> Following the below I am keen to submit comments for application 2023/1409/P. The posted paper notice was 'roof replacement' which implied a simple replacement of the existing hipped roof which is misleading when reviewing the documents online show a very significant change in bulk, mass and height that look to be out of character with the existing second floors which are all well set back from the road side.

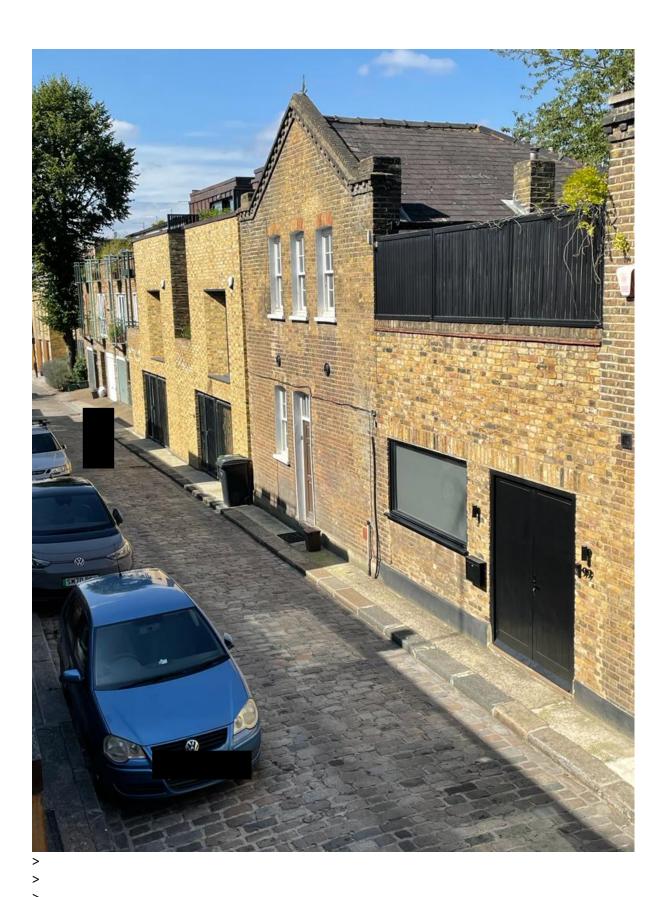
> We own and live in 99 camden mews which was originally connected to 99a and formed a single dwelling so share many characteristics and symmetrical qualities.

> I have included a photograph of 97-99 camden mews taken from an opposite neighbour I hope will add a valuable perspective to your consideration.

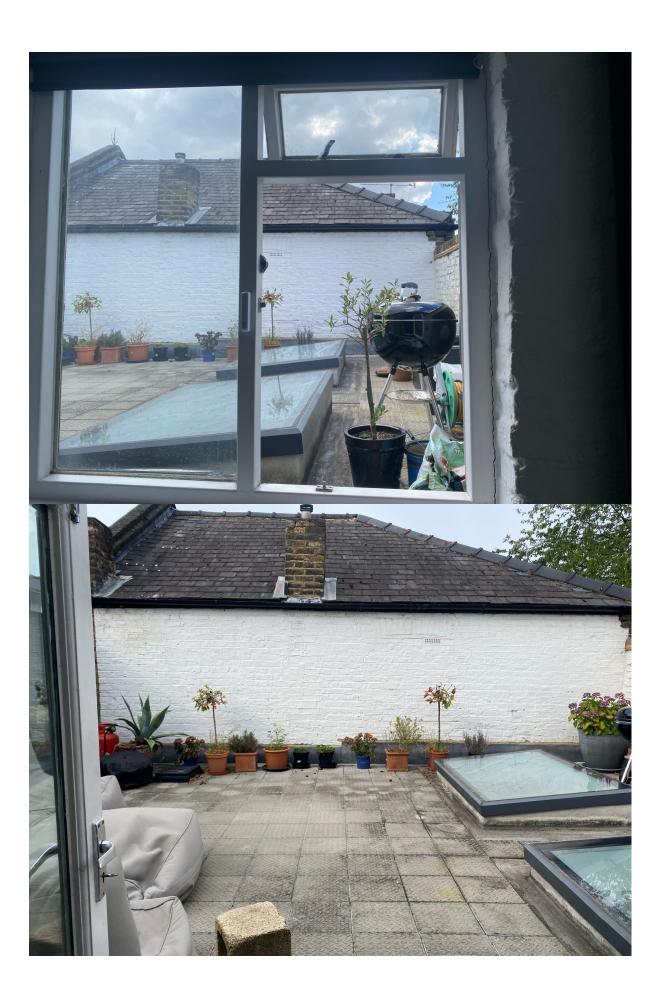
> I think the application needs to looked at in very close detail, as the existing 2 stories of 99A are already more generous than its modern counterparts. No matter how many times I review the documents it does not make sense to me that the total mass will not be higher than 97/97A when the existing two stories are more generous. This concern is better articulated by CAAC. It is not clear to me how a second storey could be 'added' to the existing roof line that would produce a floor with usable head height. The photo on page 3 of the applicants design and access statement and the later added supporting document does not resolve this but instead highlights the very different architecture and differing floor heights between 99a and 97/97a. I am very concerned it would need to be built higher than the plans suggest as the second storey on 97a, which the applicant is using as a direct comparable actually starts lower than the brick line. It is the use of clever architecture that gives this illusion from the street but the proposed second storey in 99a will start higher than the existing second storey in 97a - so how can a useable second floor starting at the existing roof line not be higher?
